**Re: Type B Water License #2BB-MRY0710
Mary River Project
Part J, Item 1 – Modification to Waste Disposal Facilities
Request for Board Approval**

Through this submission, Baffinland formally requests of the Board approval for a modification to the existing Waste Disposal Facilities at Milne Inlet and Mary River camps under Part J, Item 1 of 2BB-MRY0710. Baffinland proposes to increase temporary pond capacity through the provision of an additional two-cell pond at the Mary River camp and a single cell pond at the Milne Inlet camp. Design of this lined pond space is provided on attached drawings C701, C702, C801 and C802 stamped by a Professional Engineer licensed to practice in Nunavut.

MARY RIVER
PWSP #2
PLAN/PROFILE

Project
MILNE INLET PROJECT
BAFFIN LAND IRON
MINES CORP
BAFFIN ISLAND NUNAVUT
Drawing
MILNE INLET
PWSP #2
PLAN/PROFILE

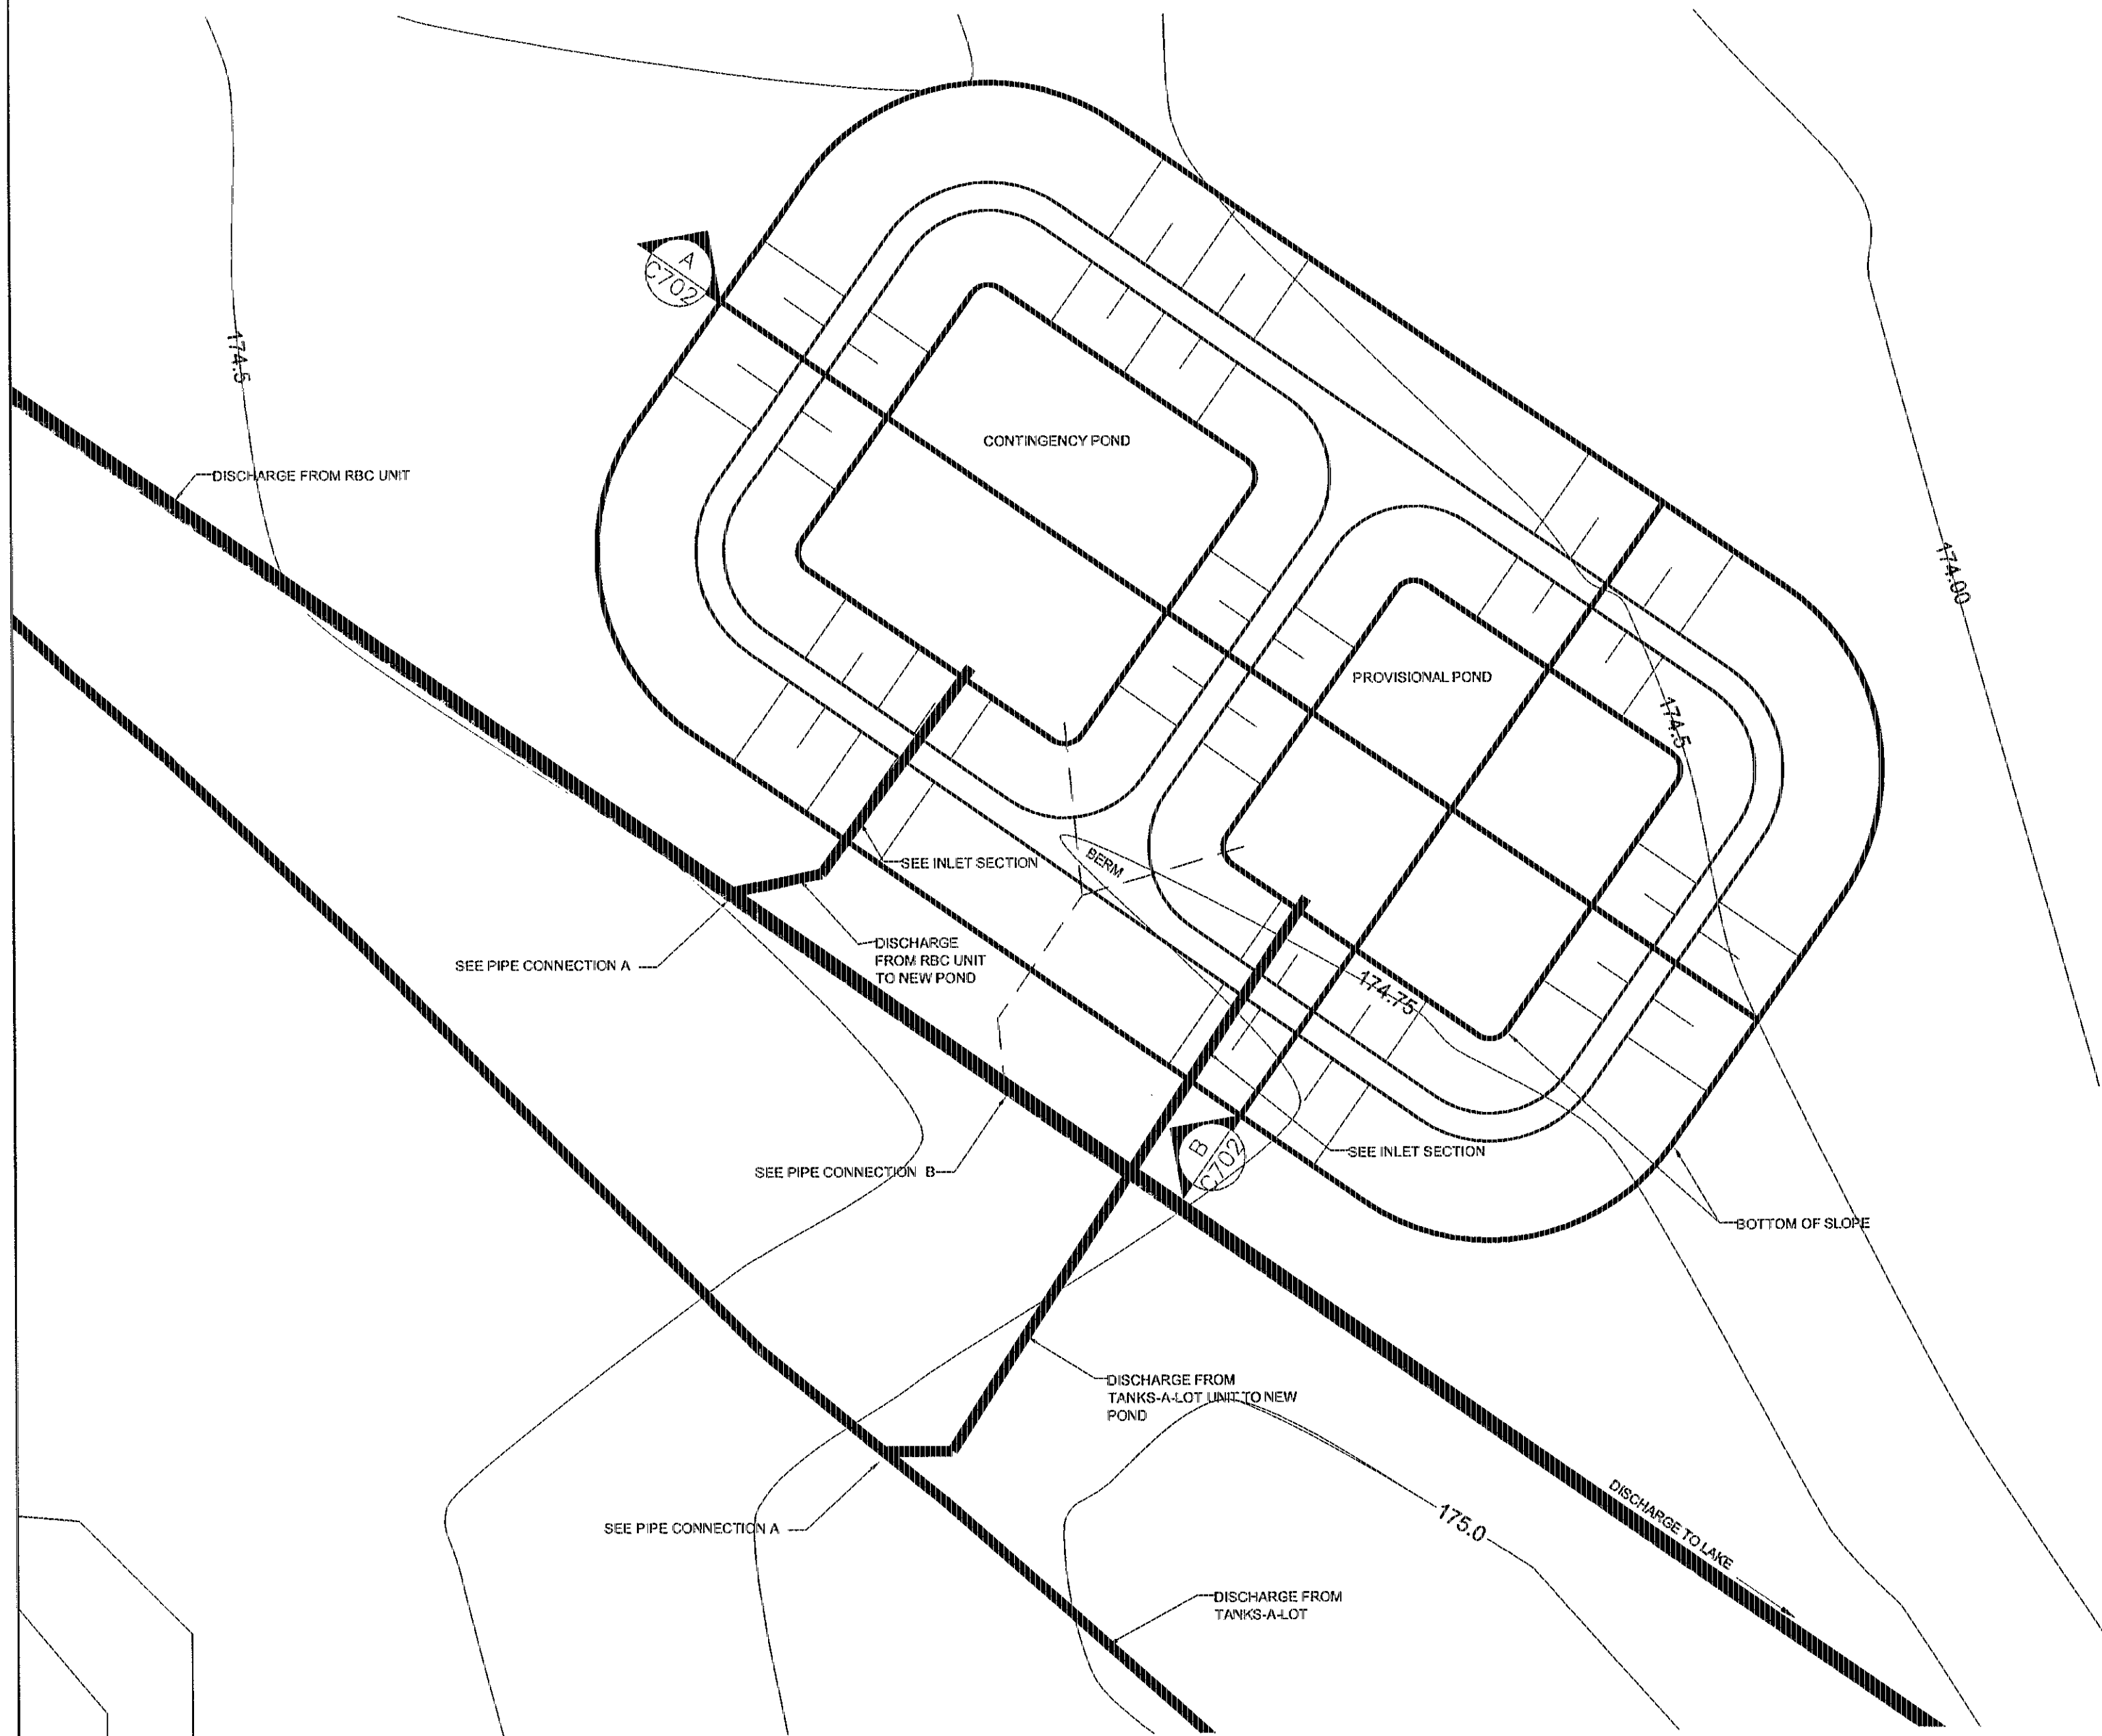
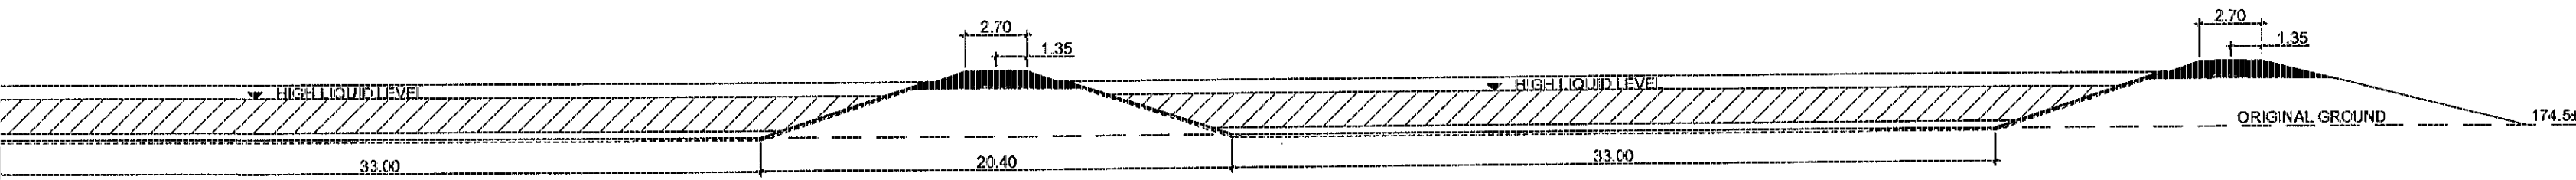
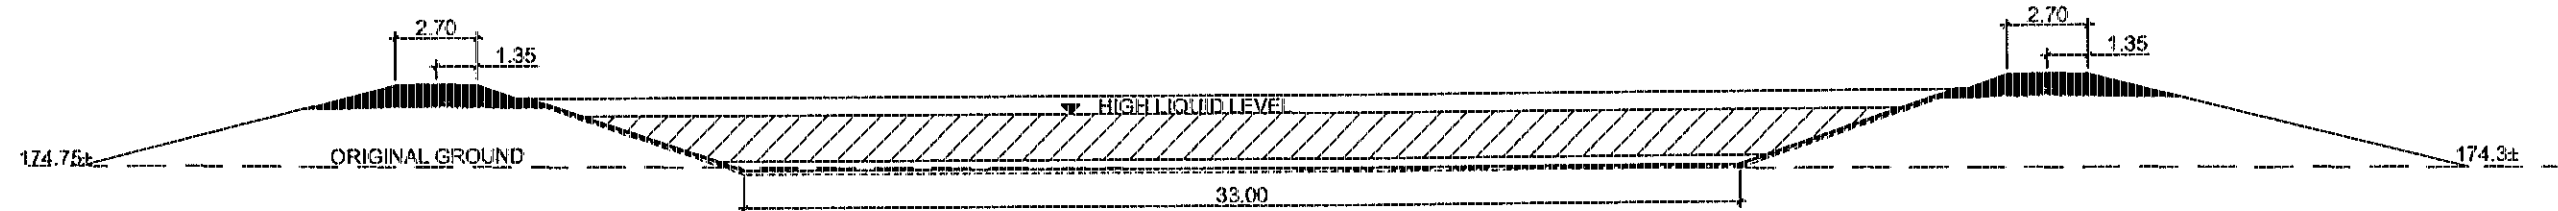
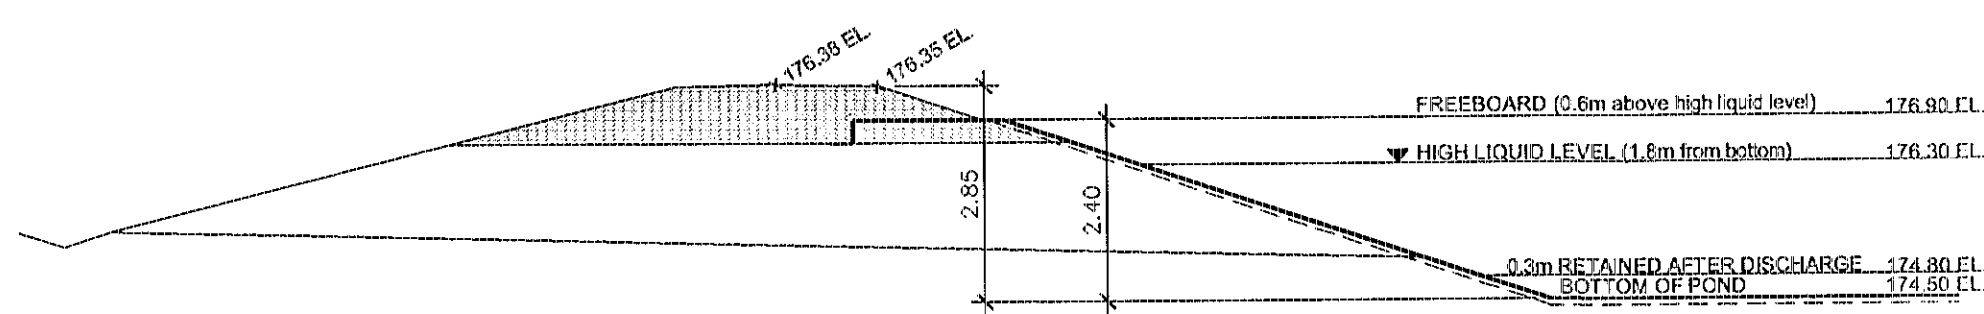
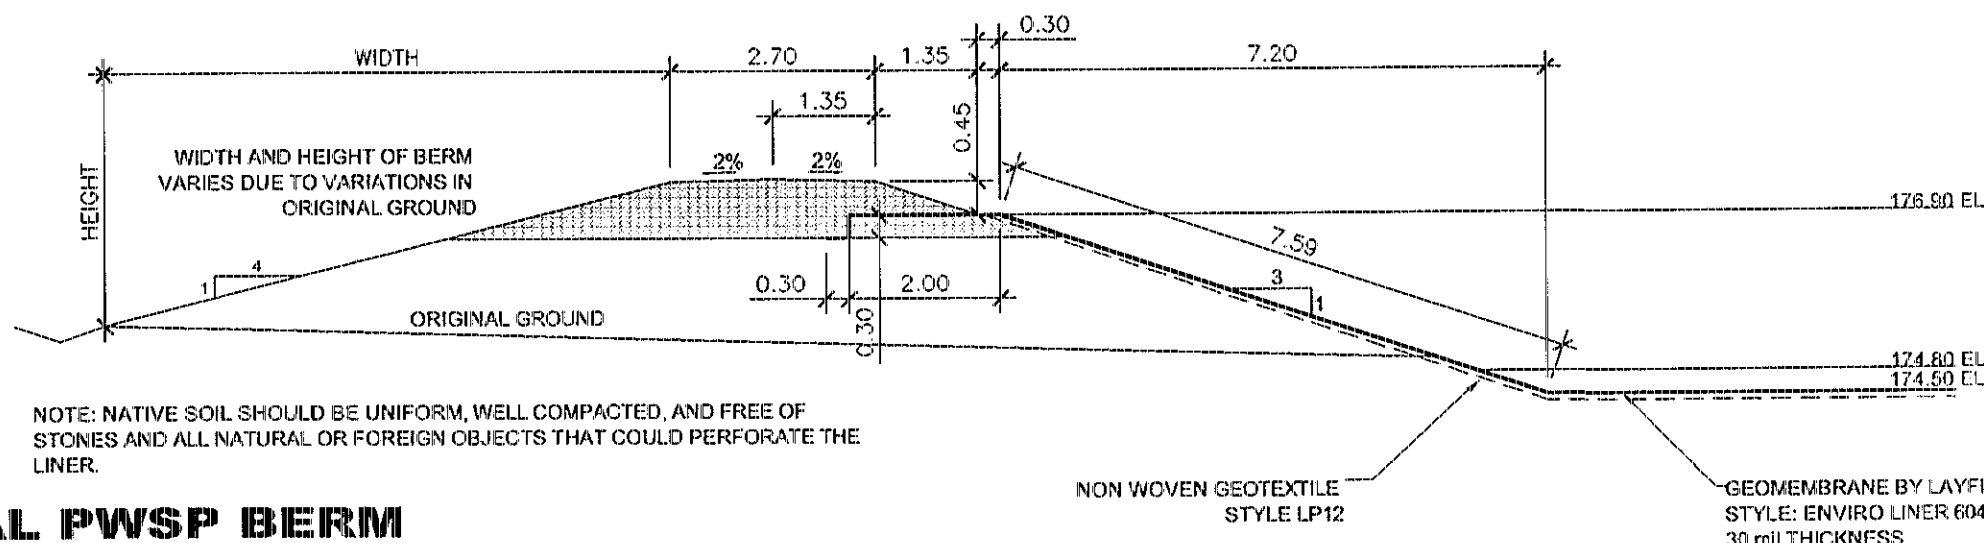
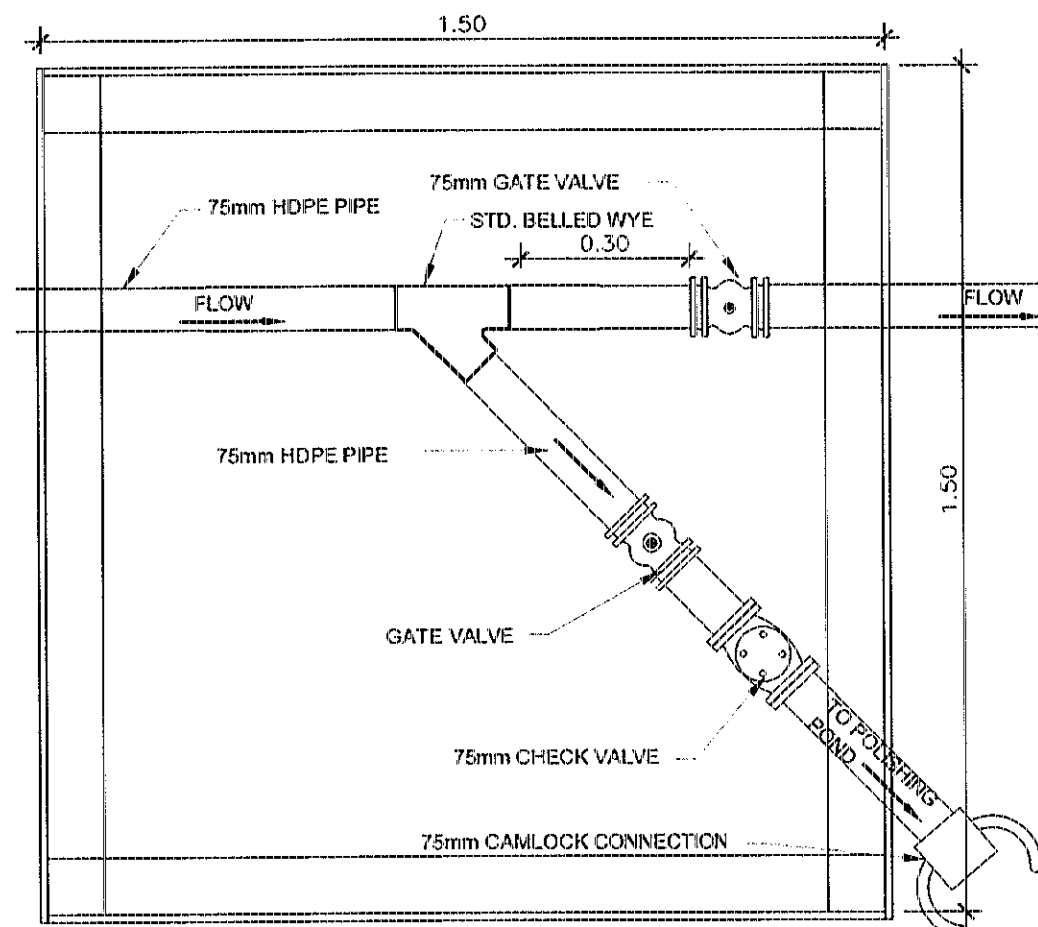
The first of the two cells proposed for Mary River will be put into operation immediately upon approval and is intended for the temporary storage of treated effluent during the continued ramp-up of the sewage treatment facility as a preferred alternative to the discharge to the Sheardown

Lake ice surface during this interim period where average effluent quality requirements have not yet been reached. In order to avoid discharge of this effluent to Sheardown Lake, additional pond space will be required within the next 4-6 weeks, in any event prior to the beginning of spring melt. Prior to the availability of the new pond space, ice from the existing pond will need to be temporarily removed and stockpiled to the satisfaction of the Inspector in order to create space for the continued discharge of liquid effluent.
